August 27, 2020

RE: Kiewit Carr Sand & Gravel (M-2020-029) Response to Adequacy Review Comments

The purpose of this letter is to respond to the comments you provided in your August 6, 2020 Adequacy Review for the Kiewit Carr Sand & Gravel 112c Construction Material Conversion Application, designated M-2020-029. The responses are formatted to match the order of the comments received.

Exhibit:  
**B**

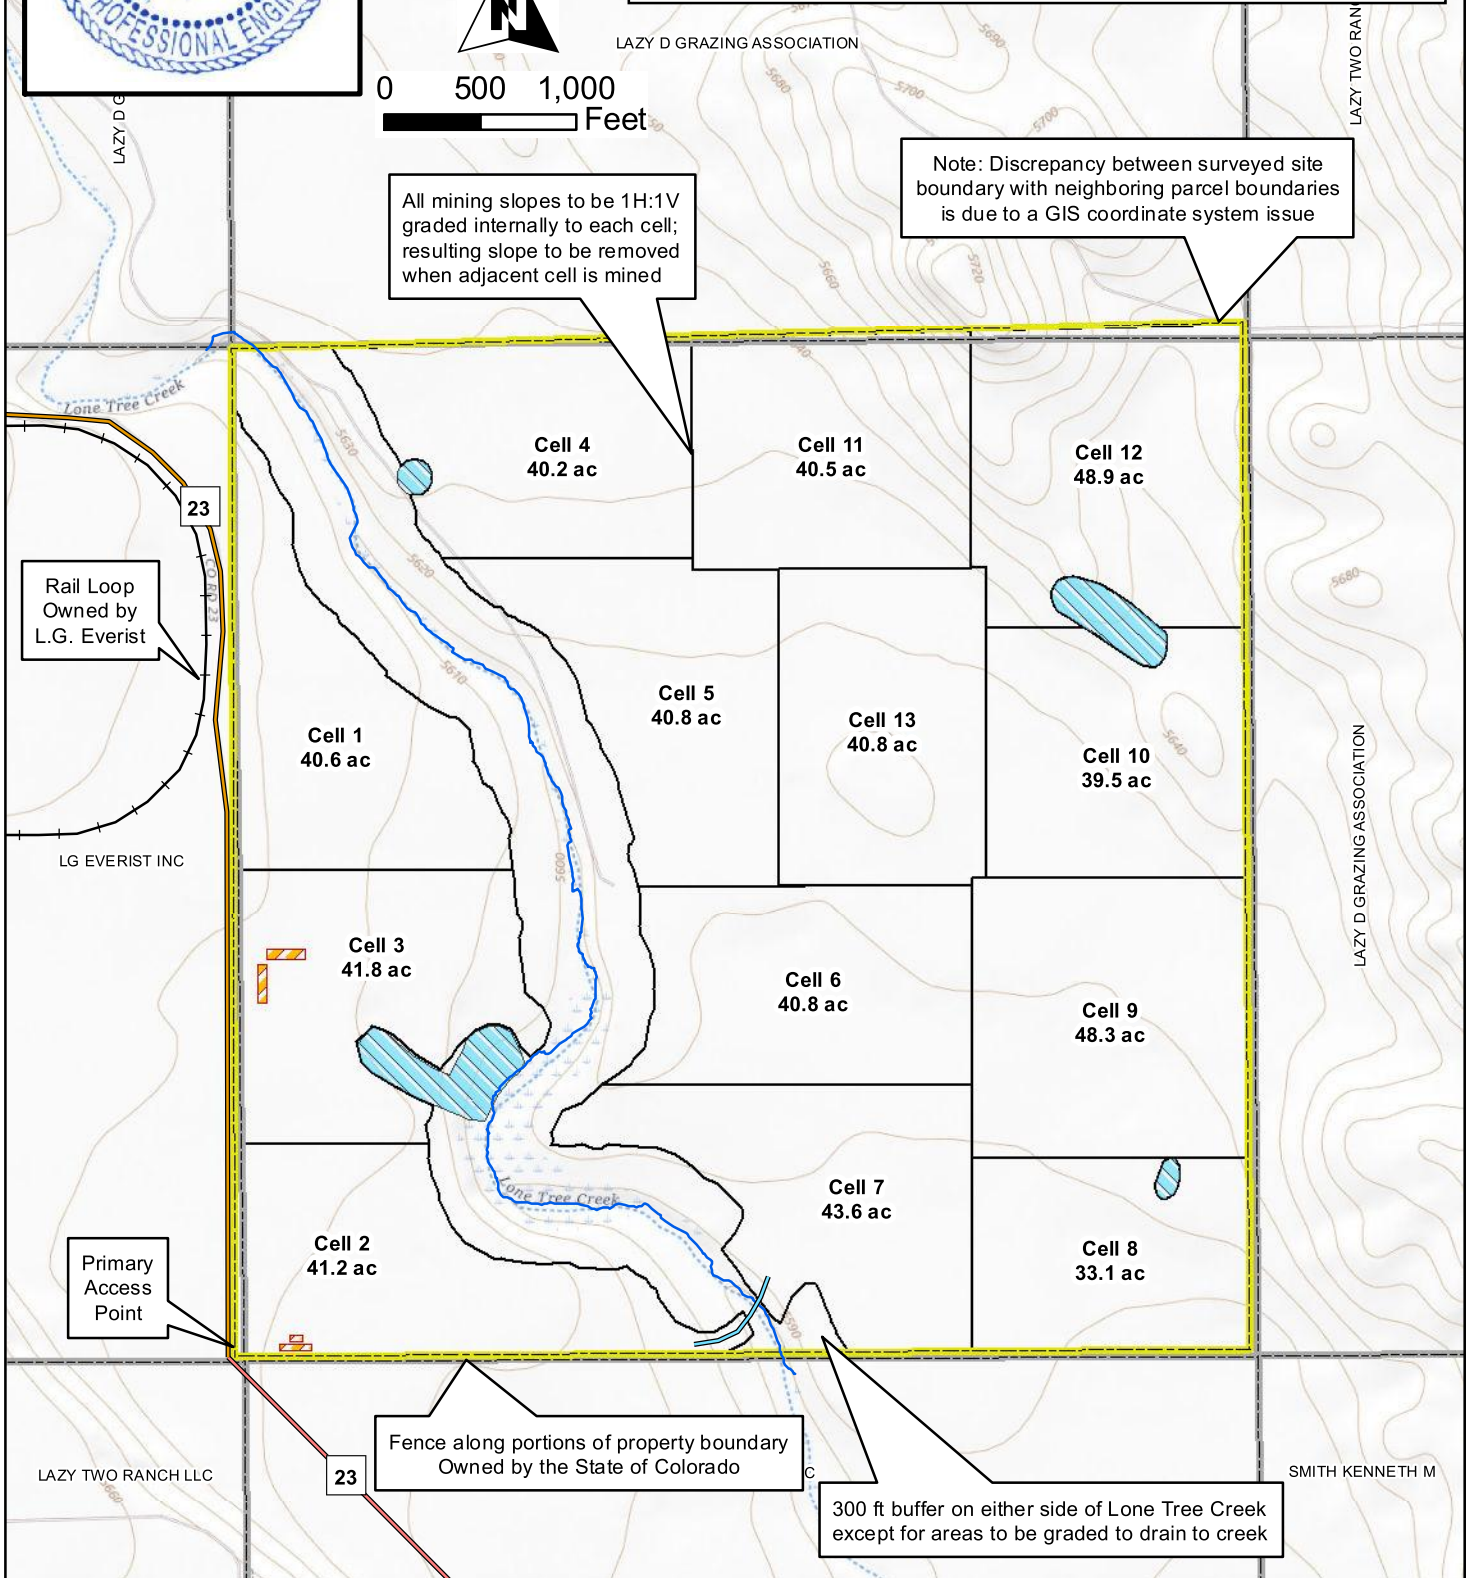
**Rule 6.4.2 Exhibit B – Index Map**

4. An updated Exhibit B more clearly labeling the adjacent roads is attached.

# C-1

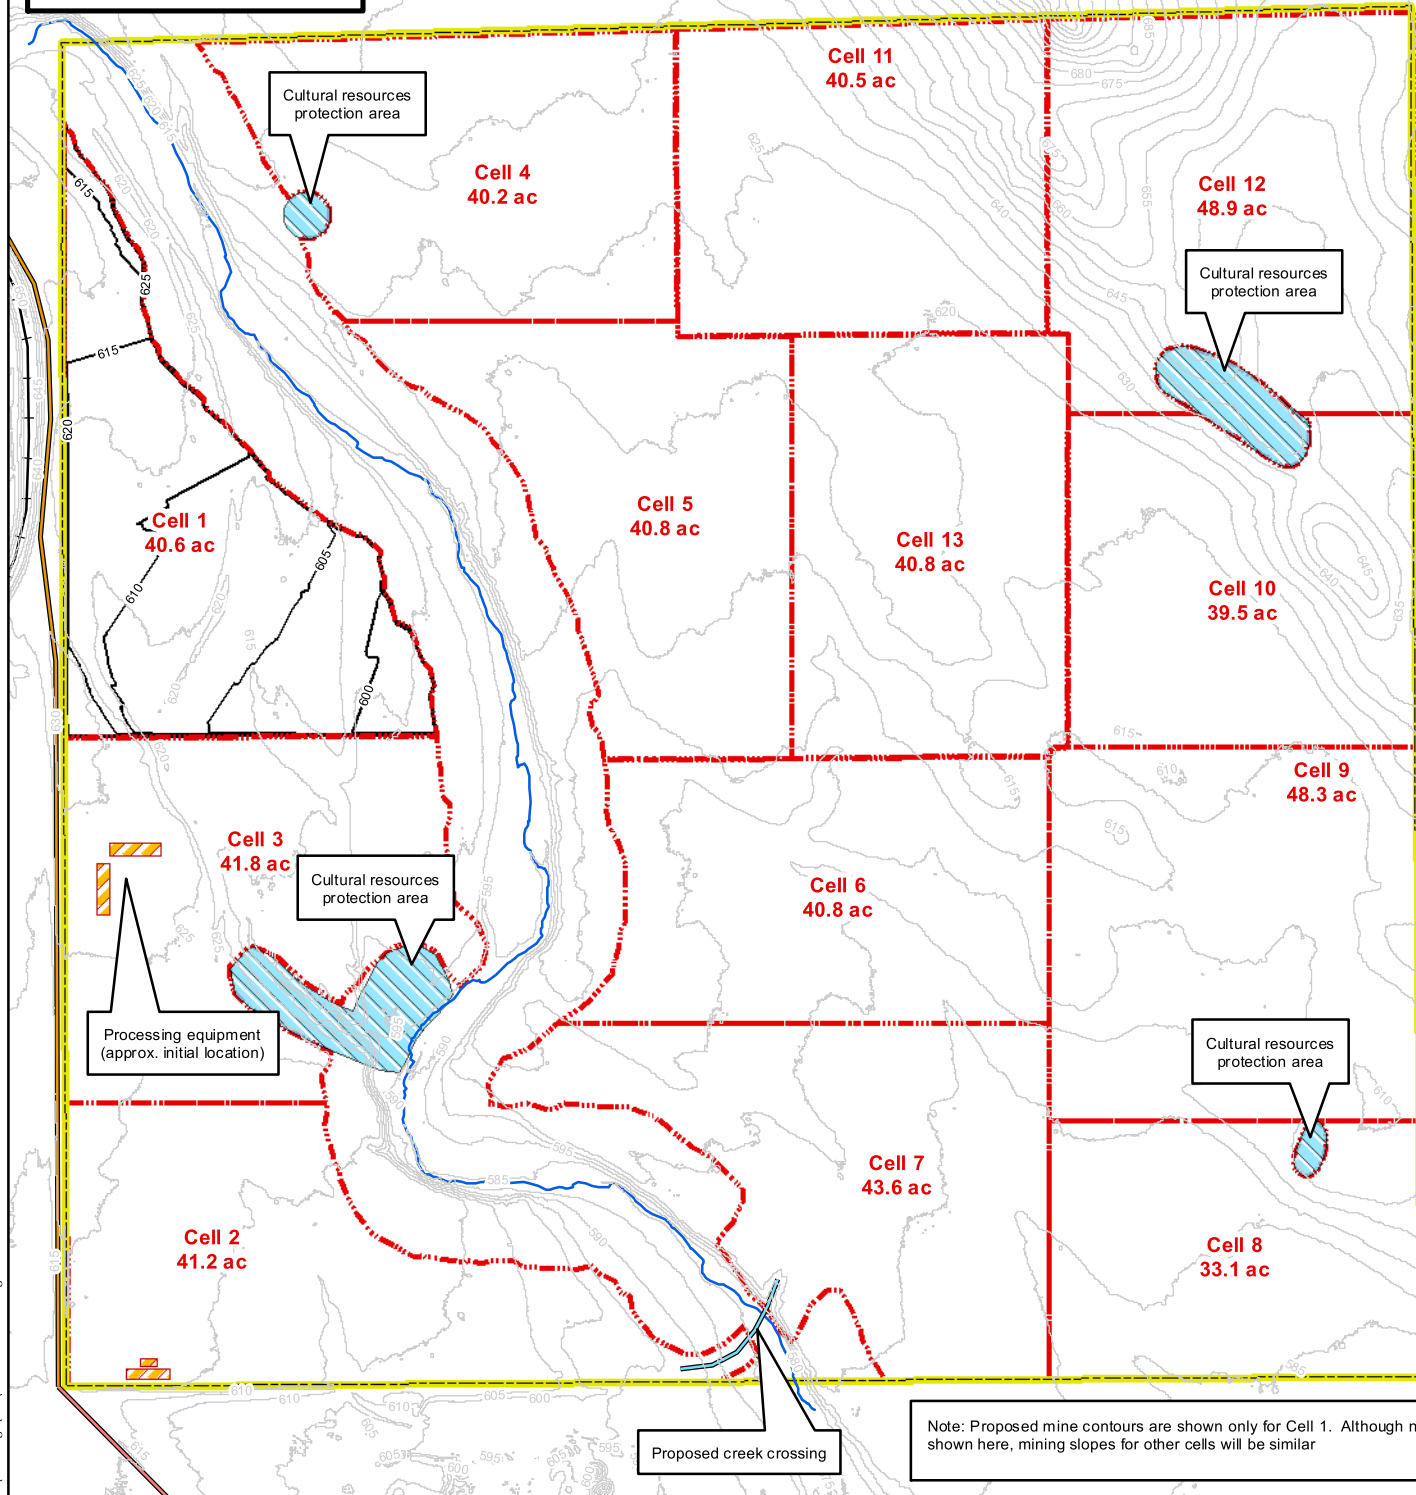
**Rule 6.4.3 Exhibit C – Pre-Mining and Mining Plan Map(s) of Affected Land**

#### **Rule 6.4.4 Exhibit D – Mining Plan**

5. Updated Exhibit C maps that include the name of the applicant and are signed by the PE who prepared the maps are attached.
6. The attached Exhibit C-1 map more clearly labels County Road 23.

7. As outlined in the response to item #1, it is Kiewit's intent that the permit boundary encompasses all 640 acres within Section 36.
8. The owner of the fence along the property boundary is the State of Colorado; this information has been added to the Exhibit C-1 map.
9. The rail line loop adjacent to Cell 1 is owned by L.G. Everist and is now labeled on the Exhibit C-1 map. As discussed during the pre-operation inspection on August 12, 2020, in our opinion the unimproved two track road designated as County Road 124 should not be considered a "significant, valuable and permanent man-made structure" for the purposes of this mining application and so it has been left off the map.

10. The attached Exhibit C-1 map more clearly labels the buffer around cultural resources on the site.
11. The proposed creek crossing is shown and labeled on the attached Exhibit C-1 map. As discussed previously, it is Kiewit's intent that the entire 640-acre section be included in the permit boundary and thus this proposed creek crossing would be included.

12. Kiewit acknowledges that any new roads built to access or haul mined material will be considered affected land. Note that the proposed north haul route to County Road 126 through land owned by the Lazy D Grazing Association has been removed from Exhibit C-1. Kiewit no longer anticipates using this proposed road as an access point.
